## Appendix C-2 IESC Comments and Response

## Appendix C-2 - Responses and Clarifications to IESC Questions

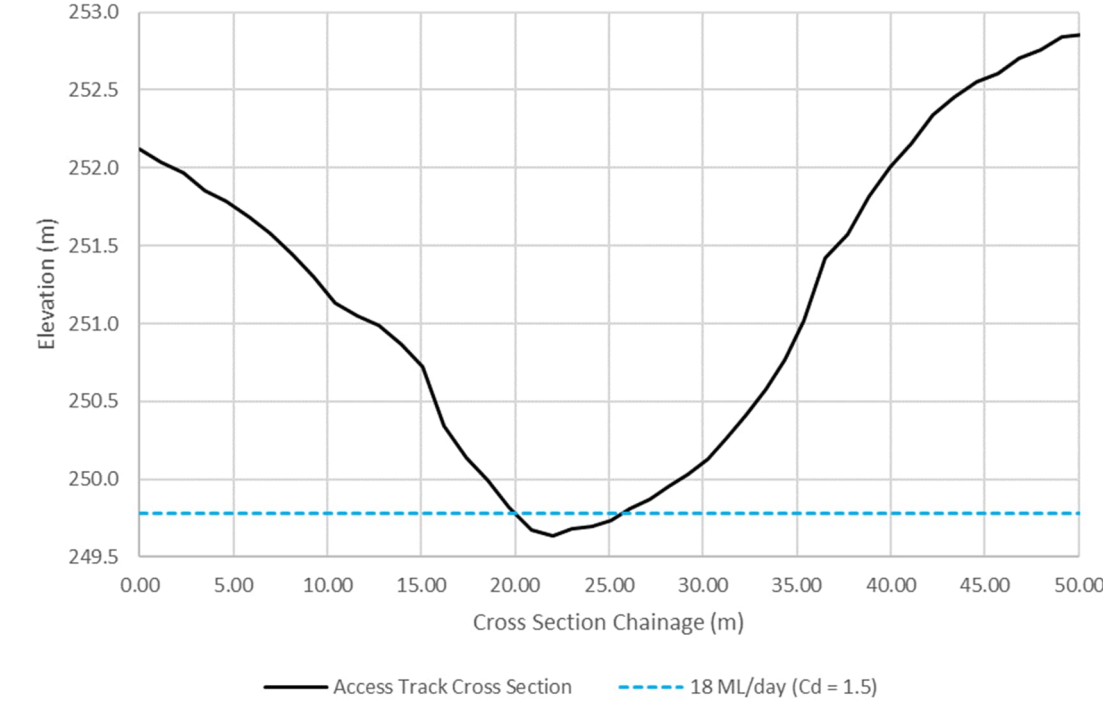
b. The treated water releases will potentially impact the tributary, waterhole and Dawson River downstream. The potentially impacted area extends from the desalinated water release point (blue dot in Figure 5.1, AECOM 2022, p. 70) to the confluence with the Dawson River just upstream of DRMP1 (AECOM 2022, Figure 5.1, p. 70) and downstream.	<p>Desalinated water releases proposed for the Gas Field Development (GFD) Project are an extension of existing water releases for the Gladstone Liquefied Natural Gas (GLNG) Project (EPBC 2008/4059) as described in Section 1.1 of the PD. Desalinated water releases to the waterhole and subsequently the Dawson River have occurred since 2015 and have been monitored and assessed under the existing REMP since that time.</p> <p>Water generation from the Fairview gas field is dynamic and variable depending on CSG well numbers and production rate. Water management of coal seam gas water prioritises beneficial reuse of water consistent with the Queensland Government Coal Seam Gas Water Management Policy (DEHP, 2012). Beneficial use data for 2021 indicates produced water end uses are:</p> <ul style="list-style-type: none"> <li>• 60% is used irrigation</li> <li>• 10% for operational activities such as dust suppression, construction, drilling etc)</li> <li>• 5% is lost to net evaporation</li> <li>• 5% as stored water including brine and</li> <li>• 20% released as desalinated water to the Dawson River.</li> </ul> <p>Produced water is treated at the Hub Compressor Station 04 (HCS04) water treatment plant via reverse osmosis (RO) to reduce salinity and chemicals. Water treatment is designed to meet EA prescribed pre-release "contaminant limits (CL) for protecting the Environmental Values (EV) for Drinking Water" (see below). The treatment process is described in Section 2.2.1.4 of the PD and summarized in the response to Question 13.</p> <p>Treated desalinated water is discharged to an ephemeral gully to bring it into equilibrium with ambient temperature and dissolved oxygen conditions prior to entering the waterhole and subsequently entering the Dawson River. Schedule B of the EA defines maximum contaminant limits for treated water that are:</p> <ol style="list-style-type: none"> <li>below acute toxicity limits prior to discharge at the head of gully release point – Schedule B Table 4; and</li> <li>protection of the drinking water EV at the compliance point S4 at Yebna Crossing – Schedule B Table 5</li> </ol> <p>Predicted P50 desalinated water inflow to the ROP plant for both the GLNG and GFD projects and the forecast Dawson River discharge requirements are provided in Section 2.3.2 of the PD document and are presented in the following graph.</p>	Section 2.2 Section 9.0

No	IESC COMMENT	Response and /or Clarification	Clarification location in PD
		<div><p>P50 model for ROP2 inflow from GLNG (green) and GFD (grey) projects</p><p>P50 Forecast Monthly Dawson River release plot to 2035</p><p>The REMP program presented in Appendix J (and reported in Appendix F) of the PD is required by the State EA (Condition B36 to B41) to monitor the receiving environment for potential impact and where required, implement actions and responses triggered by REMP data. REMP monitoring has included ecosystem health monitoring based on SIGNAL 2 scoring (Stream Invertebrate. Grade Number - Average Level1 - scoring system) for both the waterhole and Dawson River upstream and downstream of the desalinated water confluence. Ongoing desalinated releases in accordance with State EA condition requirements under the GFD Project have been found unlikely to significantly change the existing condition of the receiving environment that has been receiving treated desalinated water from the GLNG Project since 2015.</p></div>
